**Re: Defect Information Report – Supplemental Report No. 2
10V-468 & 10V-472, 10C-6, MBE900 EPA07 Reprogramming**

**Subject: Safety Recall 10C6
MBE900 EPA07 MCM Reprogramming In School Bus and
Emergency Vehicle Applications**

Subject: **Safety Recall 10C6**
MBE900 EPA07 MCM Reprogramming In School Bus and
Emergency Vehicle Applications

Figure 1 – Software And Fuel Map Version Number

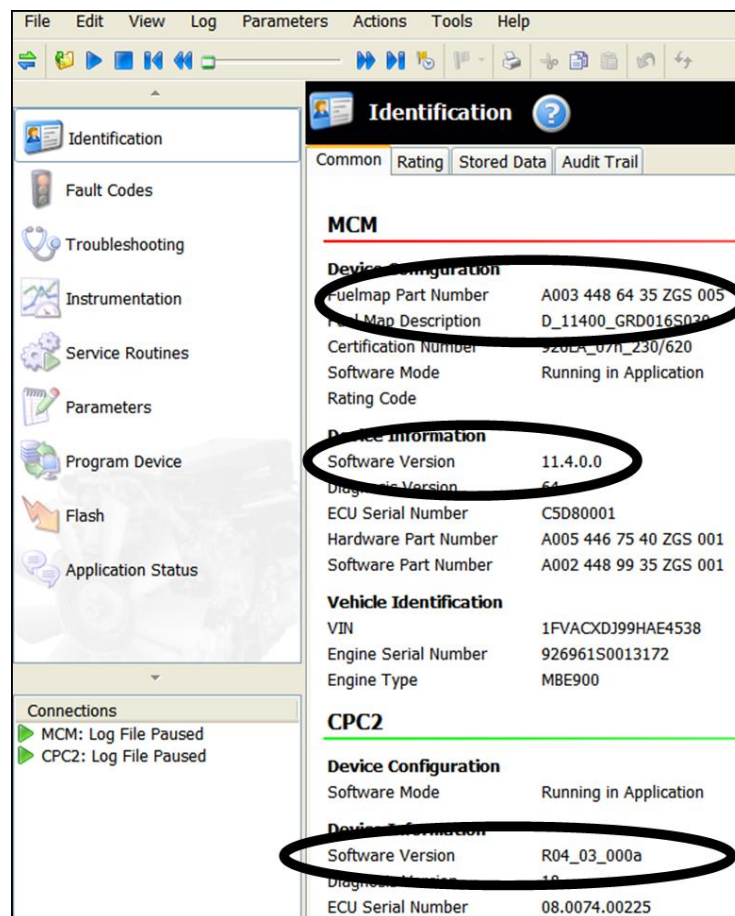
1. Apply the parking brake, chock the wheels, and perform any other applicable safety steps.
2. Using the “Identification” screen in DDRS, check the MCM software level and fuel map version. See Figure 1. In this example, the MCM software level is 11.4.0.0 and the fuel map version is the last three digits of the fuel map part number after the letters ZGS which is 005.

4. Using the “Identification” screen in DDRS, check the CPC software level. See Figure 1. In this example, the CPC software level is r4.03. If the CPC is not at r4.03 software or higher, program it using the “Update Device Software” option. Select “No Charge”, then “Description”, and enter “10C6” in the “Provide Reference” box.

3. If the MCM is not at software 11.4.0.0 with fuel map version 005 or higher, program it to 11.4.0.0 or higher using the “Update Device Software” option. Select “No Charge”, then “Description”, and enter “10C6” in the “Provide Reference” box.
